# PERMIT

SEWAGE DISPOSAL SYSTEM

MARYLAND STATE DEPARTMENT OF HEALTH

A SEWAGE DISPOSAL-SYSTEM LOCATED AT Bushy Park Road - approx. 100 ft. to right  
of Cemetery Rd.

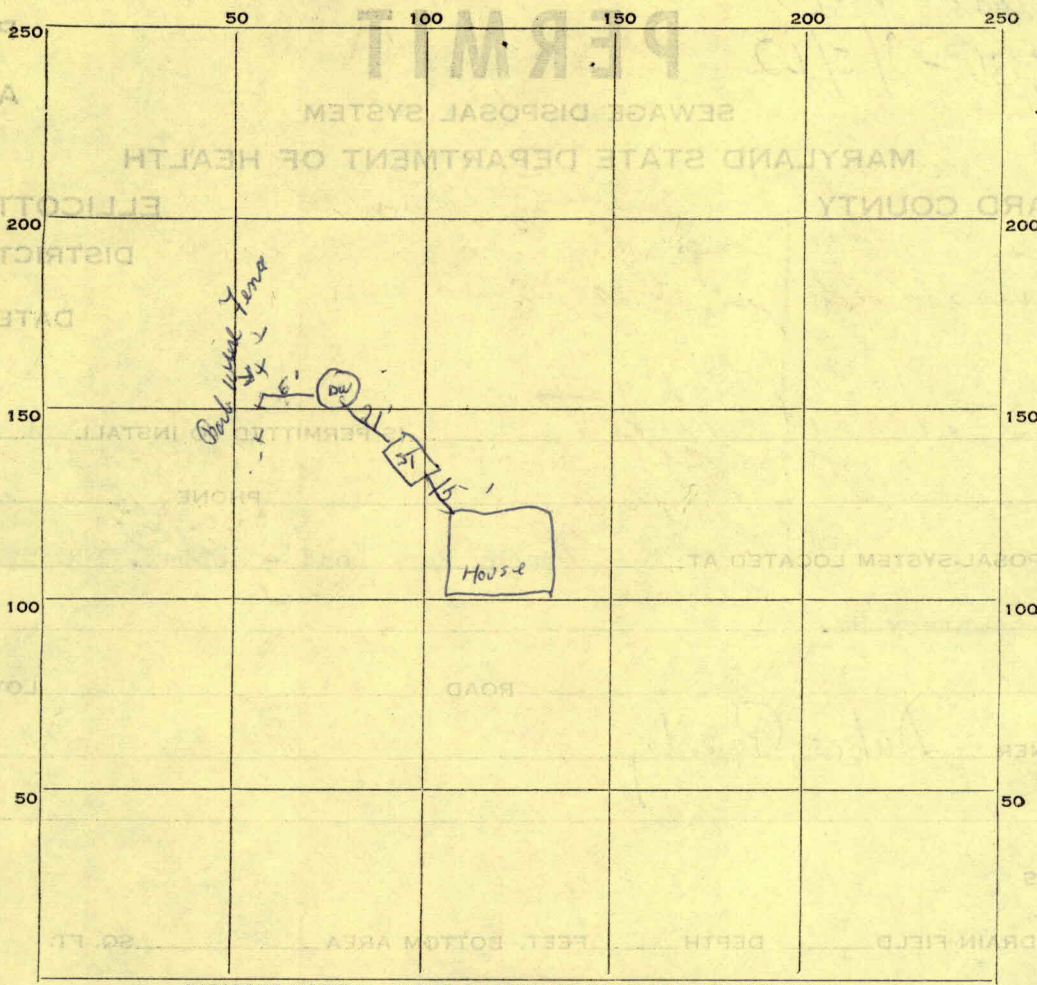
REMARKS: *Dry Well system should be about 30 to 40 ft from fence not 6 ft*  
*Cleanout pipe an. Dry Well cemented tight - could not measure depth 1 1/2 / 15 / 4 DWM*

OTHER Place the dry well about 110 ft. to 130 ft. from Bushy Park Road and  
about 30 ft. to 50 ft. from the barbed wire fence on the sideline.
